PLANNING BOARD OF THE CITY OF PANAMA CITY BEACH

IN RE: HEIGHT INCENTIVES REQUEST to increase the allowable height in the FBO-1 district from 35' to 45' for PROPERTY LOCATED at 16515 Front Beach Road

ORDER

**CITY OF PANAMA CITY BEACH
PUBLIC NOTICE OF HEIGHT INCENTIVE REQUEST**

PROPOSED WEST ELEVATION

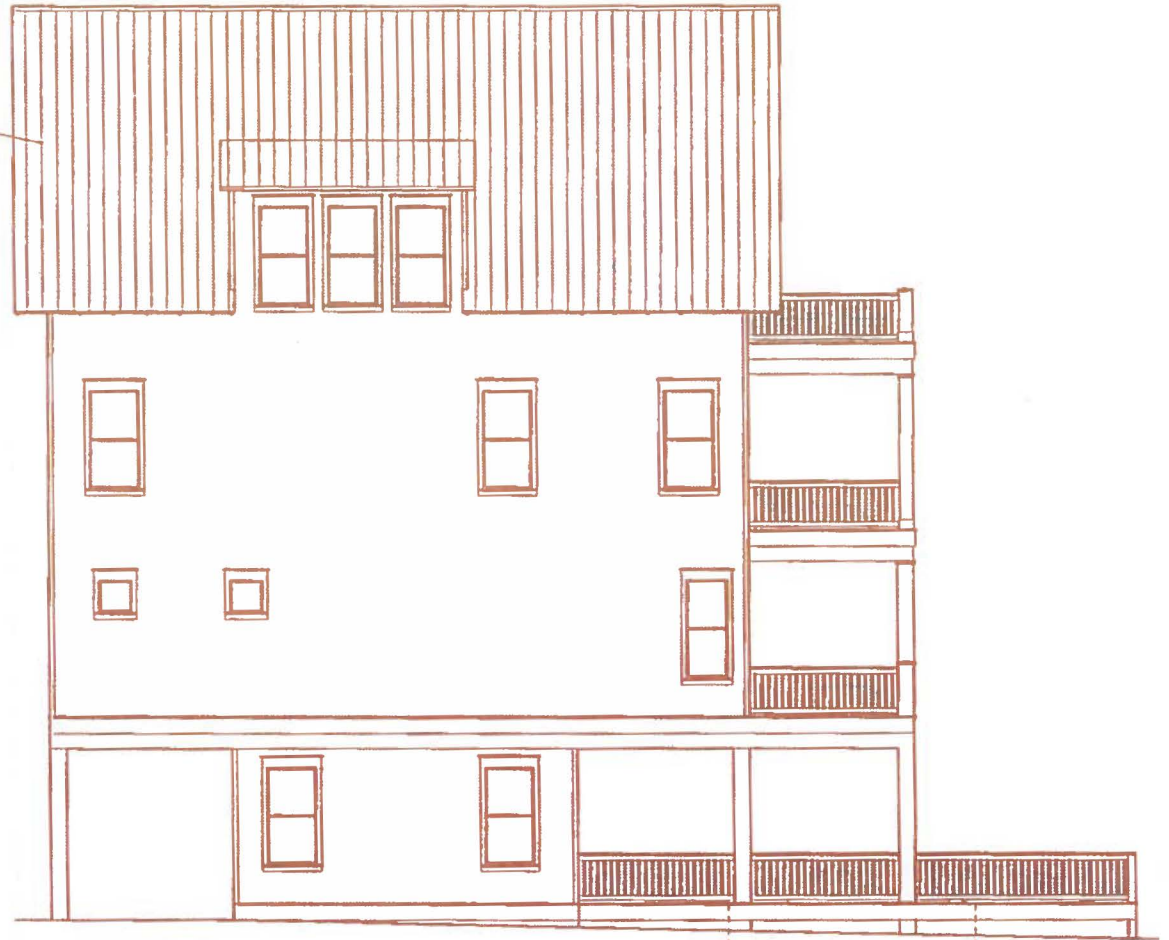
Staff analysis: The proposal meets the minimum conditions of solar reflectance.

#1 Height Incentive Requested per Table 4.02.02B: Use roofing materials with a solar reflectance index (SRI) of at least 78 for a sloped roof equal to or less than 2:12 and a SRI of at least 29 for a sloped roof greater than 2:12. Green Development, Height Bonus = 5 feet

**#2 Height Incentive Requested per Table 4.02.02B: Water conservation measures outside the building that includes: 50% or more Florida Friendly Plants.
Green Development, Height Bonus = 5 feet**

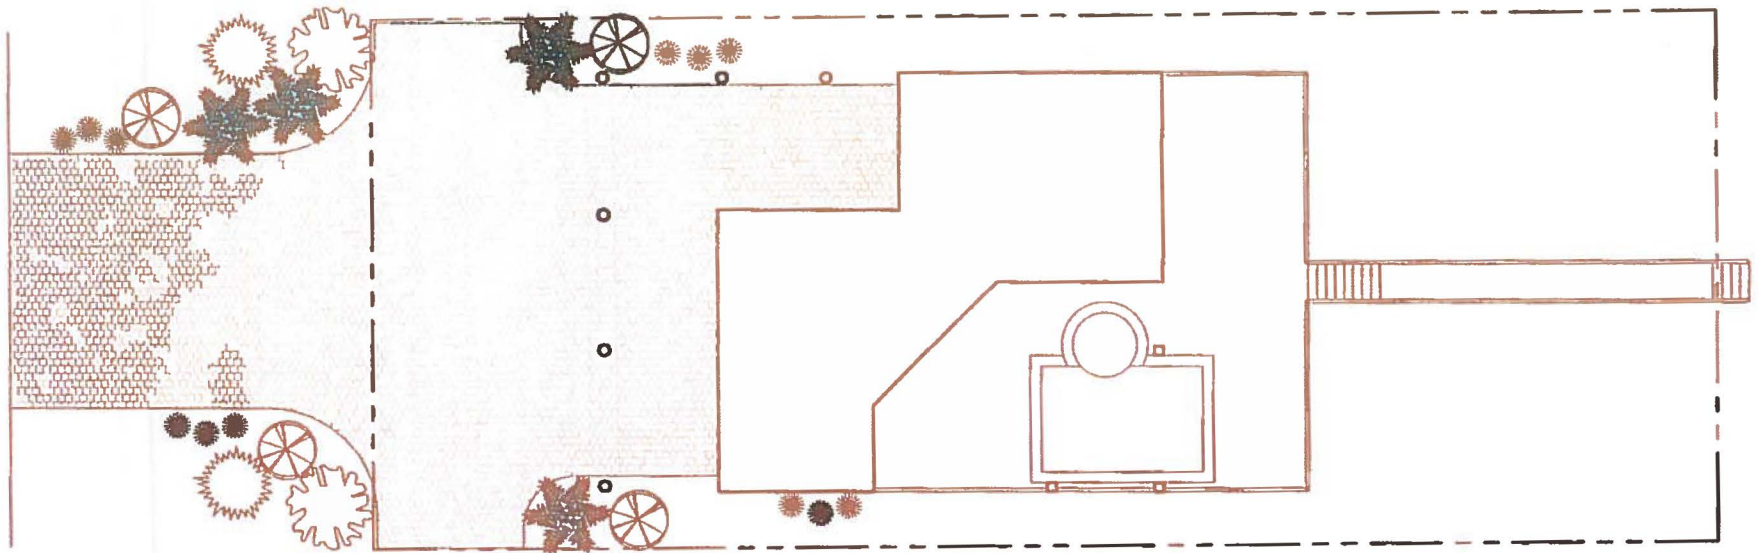
Staff analysis: The proposal meets the minimum conditions of water conservation measures outside the building, 50% or more Florida Friendly Plants.

**#3 Height Incentive Requested Per Table 4.02.02B:
Lighting-architectural lighting highlighting building columns, Cornices or other distinguishing architectural features along the front façade of buildings.
Architectural Amenities, Height Bonus = 5 feet**

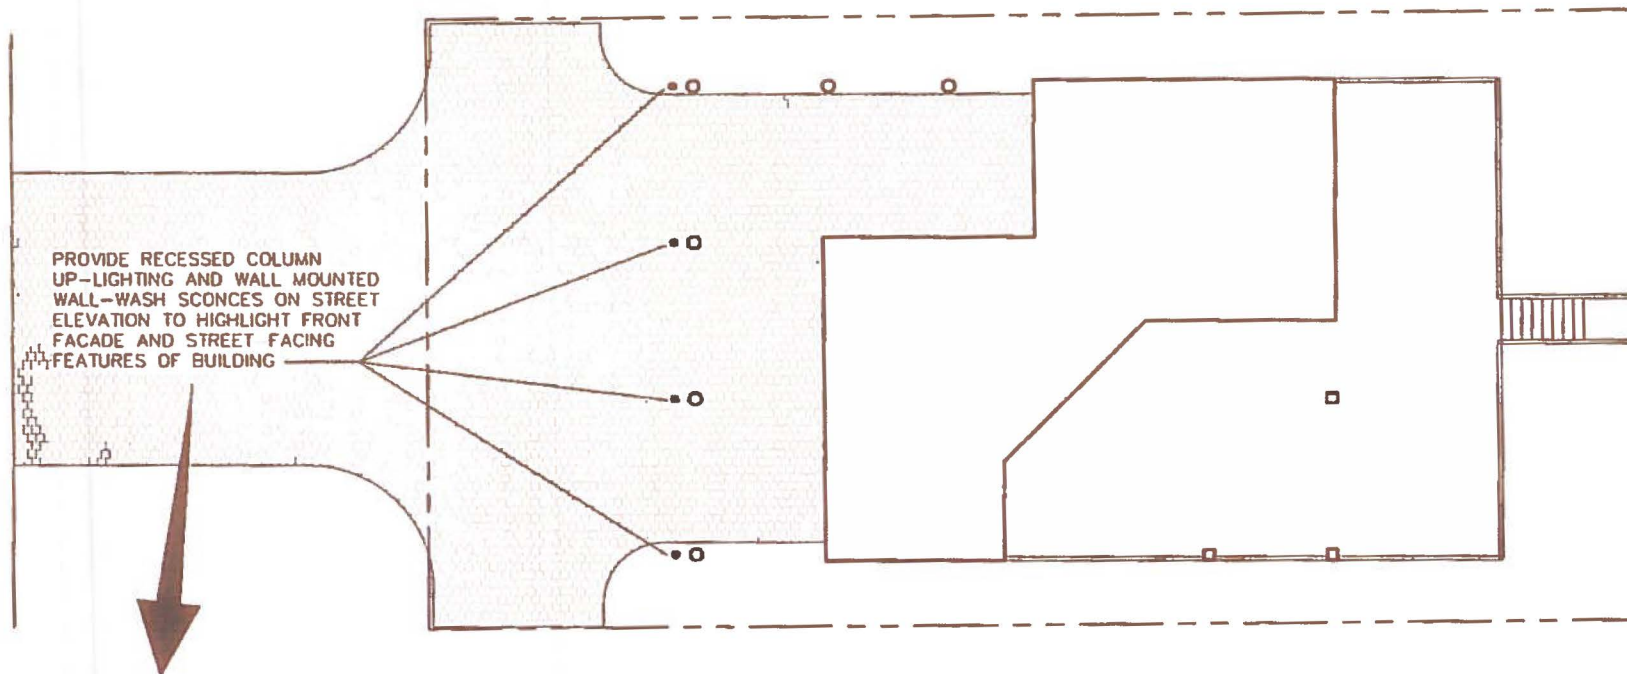
Staff analysis: The proposal meets the minimum conditions of architectural lighting.
